EPA Comment**G-10 Ground water basin modeling and ground water chemistry**

Subject: Partial Response to Environmental Protection Agency (EPA)
September 2, 2004, Letter on Compliance Recertification Application

In response to the EPA's letter of September 2, 2004, the U.S. Department of Energy (DOE) is providing information that answers some of the questions included in the enclosure to that letter. DOE determined, after review of the EPA September 2, 2004 letter, that the responses to several of the items, including those that address the technical areas of concern, required additional analysis or significant effort.

Figure 1. Trilinear diagrams for samples collected from WQSP Culebra wells from 1995 through 2003 (2003 results highlighted).

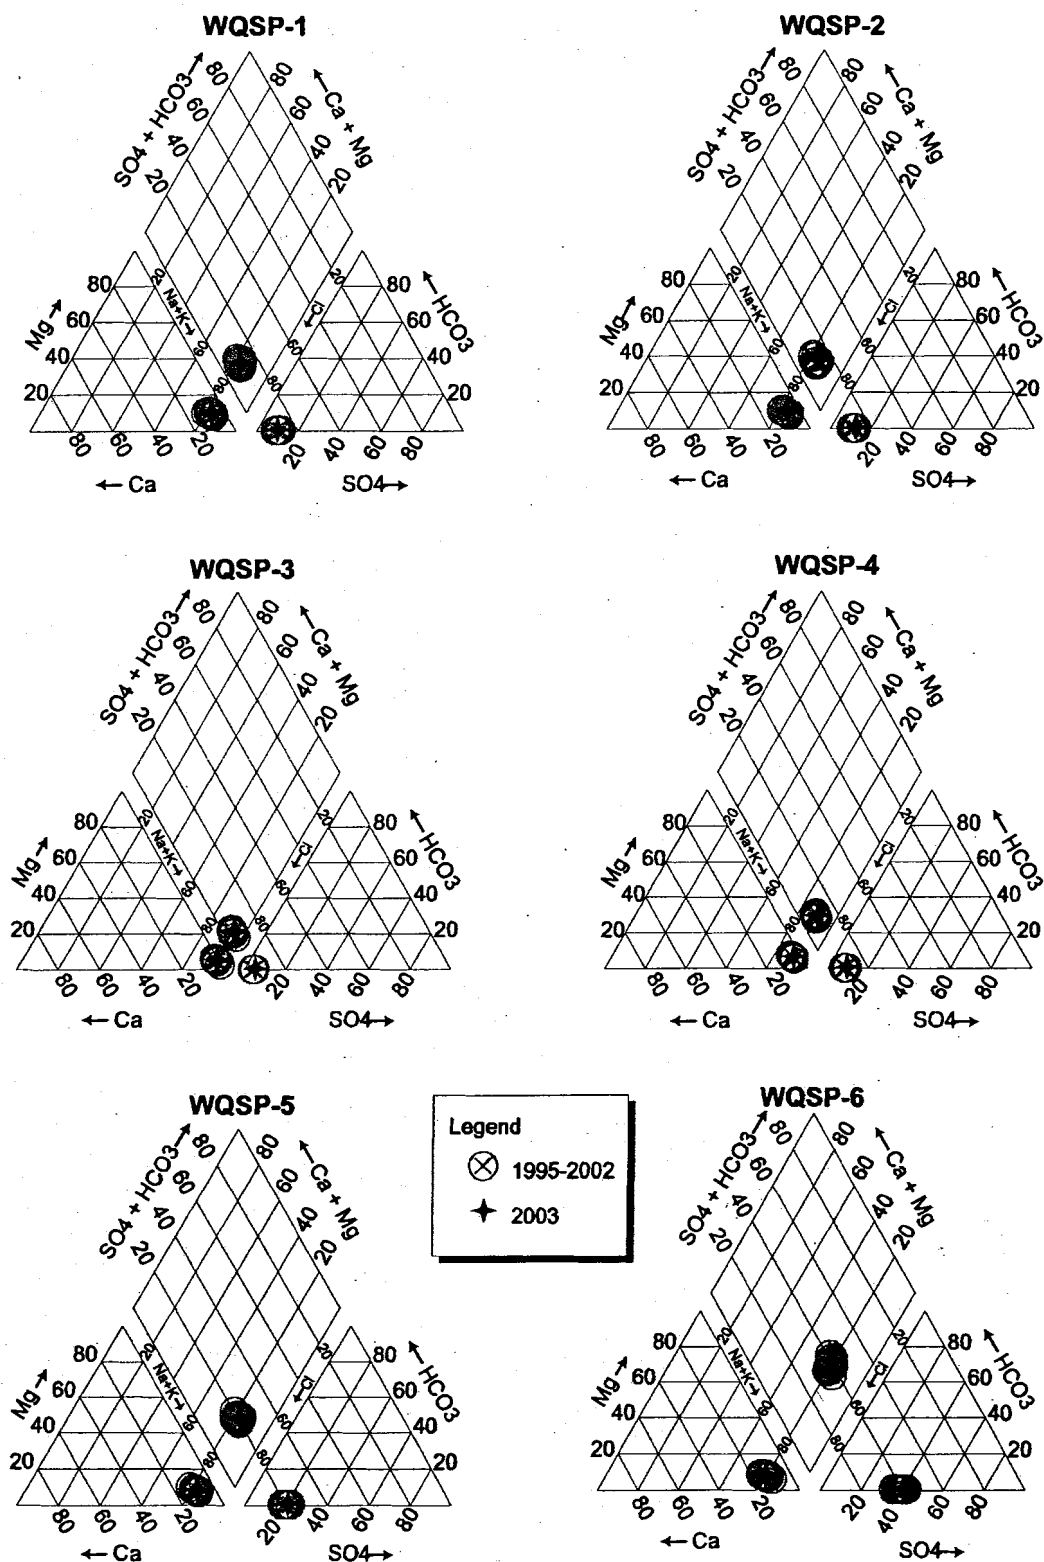
Since DOE submitted the original certification application (CCA), new information has become available on the Culebra hydrology and potential recharge related to potash mining. The possibility of potash mining as a potential source of recharge could affect previous interpretations of the ground water chemistry and ground water basin modeling that was done for the CCA. DOE must update the ground water basin modeling and ground water chemistry to accommodate the possibility that potash mining is a potential source of recharge. DOE must also provide discussion on how this new information would or would not affect the current performance assessment.

With regard to groundwater chemistry, the DOE's conceptual model at the time of the CCA already included the idea that potash mining was responsible for the facies D groundwaters found in Nash Draw (Siegel et al. 1991). Twice-yearly sampling at the WQSP wells on the WIPP site conducted since 1995 (DOE 2004) has shown no changes in hydrochemical facies at these wells (Figure 1). Culebra groundwater samples have recently been collected, or will be collected in 2005, at wells between the Intrepid East Tailings Pile and the WIPP site (SNL-1, 2, 3, 5, and 9 and WIPP-30), as well as in Nash Draw (WIPP-25 and 26), to determine if potash brine is affecting hydrochemical facies elsewhere.

In any case, Culebra water quality enters into PA calculations only with respect to selection of K_d values for radionuclides. Culebra K_d s were evaluated for four brines: a Castile brine like that found at ERDA-6, a Salado brine (Brine A), and two Culebra brines (from the Air Intake Shaft and H-17) (Brush and Storz 1996). To be conservative, two ranges of K_d values were calculated for each radionuclide, one for the two Culebra brines and one for the Salado and Castile brines, and the lower of the ranges are used in PA calculations. K_d s were found to generally decrease with increasing ionic strength, hence the K_d s determined for Castile and Salado brines were used in PA calculations for all radionuclides except Np(V), for which the uncertainty range for Culebra brines was 1 to 200 mL/g, while the range for Salado and Castile brines was 2 to 200 mL/g (Brush and Storz 1996). Brine from the Intrepid East tailings pile (as sampled at SNL-1 (Powers and Richardson 2004)) is similar in ionic strength to Salado and Castile brines (Table 1). As it migrated over seven miles to the WIPP site, it would be significantly diluted with less saline Culebra brine. Therefore, the K_d s determined for the higher ionic strength Salado and Castile brines would be lower (more conservative) than K_d s determined for the mixed potash-Culebra brine. Consequently, any change in Culebra groundwater chemistry at the WIPP site resulting from potash mining would have no impact on compliance calculations.

Figure 1. CRA PA and CCA PAVT Total Release Means, All Replicates Averaged

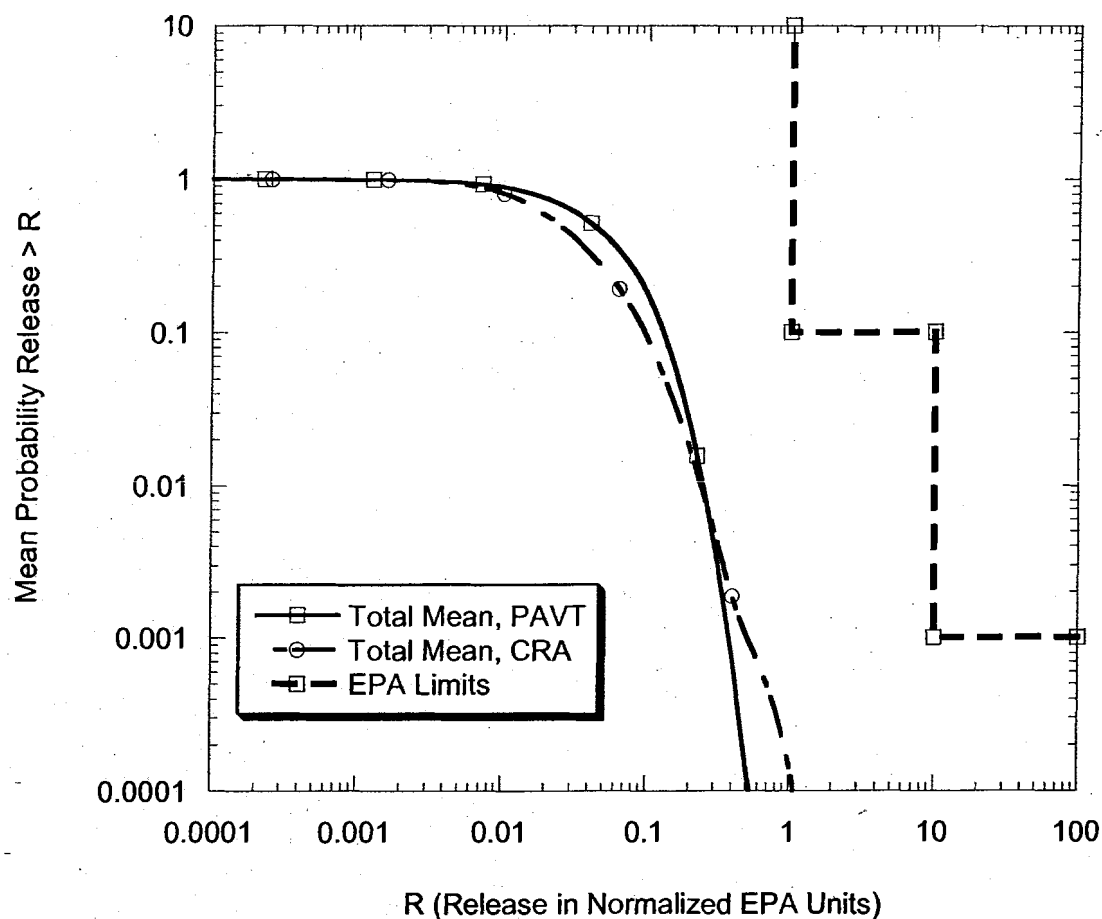
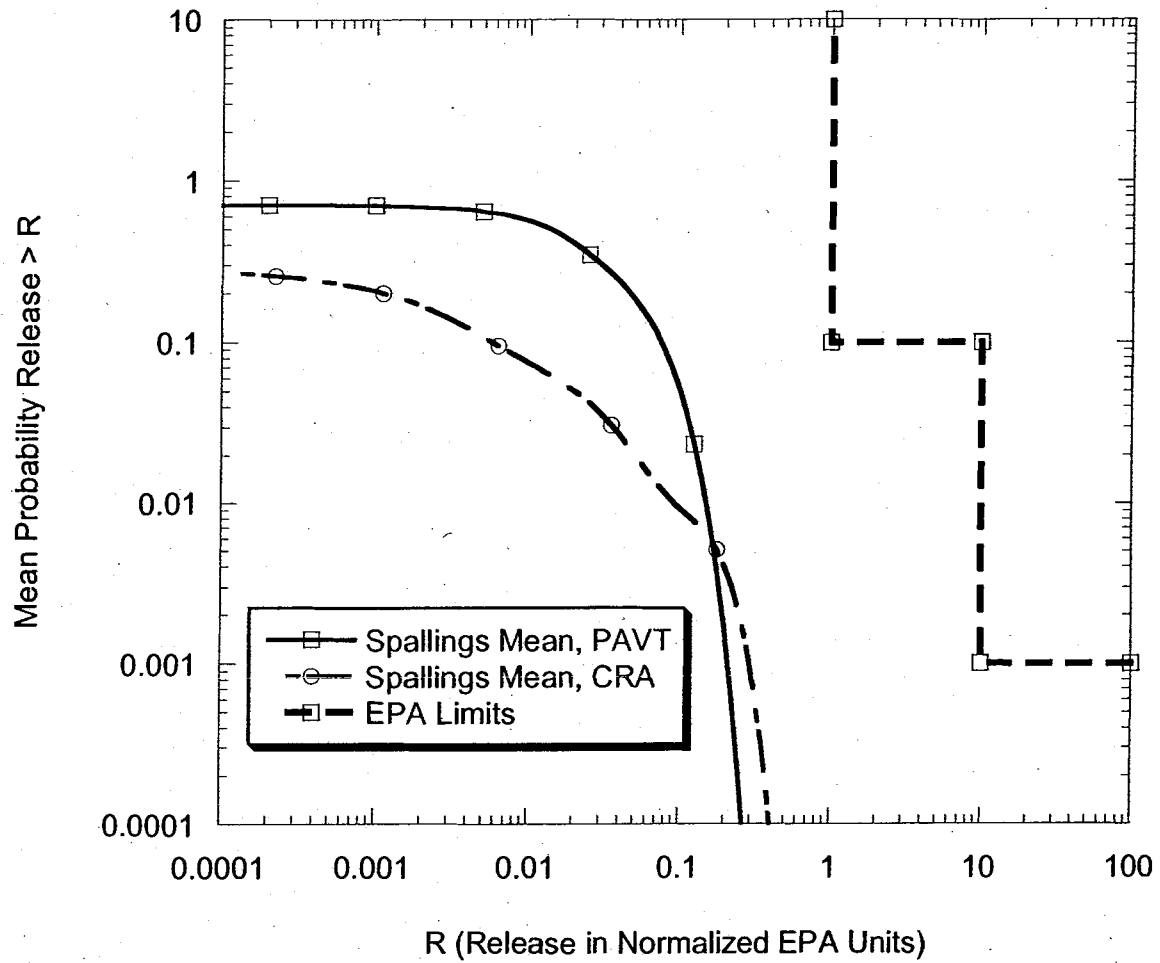
The previous baseline for DOE's compliance (from the initial certification decision completed in 1998) is the Performance Assessment Verification Test (PAVT) set of CCDFs and releases at the regulatory limits. To provide context for understanding the changes from the previous baseline, DOE must provide a comparison of the CCA PAVT results to the results of the CRA PA in a tabular form with columns/rows for 0.1 and 0.001 probabilities. For the table, use as an example the table submitted as part of the review of super compacted waste (Comparison of AMW and PAVT Results with CRA Results by C.W. Hansen, March 19, 2004. ERMS 534241 and EPA Docket A-98-49, Item II-B2-34).

The CRA PA total releases at probabilities of 0.1 are smaller than the CCA PAVT total releases (Figure 1) at the same probabilities due to a decreased contribution of spill at this probability. The typical spill release in the CRA PA at a probability of 0.1 is smaller than the typical spill release in the PAVT CCA at the same probability (Figure 2).

The CRA PA total releases at probabilities of 0.001 are larger than the CCA PAVT total releases (Figure 1) due to the presence of several small volume, high activity waste streams in the new inventory that cause an increase in the cuttings and cavings releases at very low probabilities (Figure 3). Additionally, the typical spall release in the CRA PA at a probability of 0.001 is larger than the typical spall release in the PAVT CCA at the same probability (Figure 2).
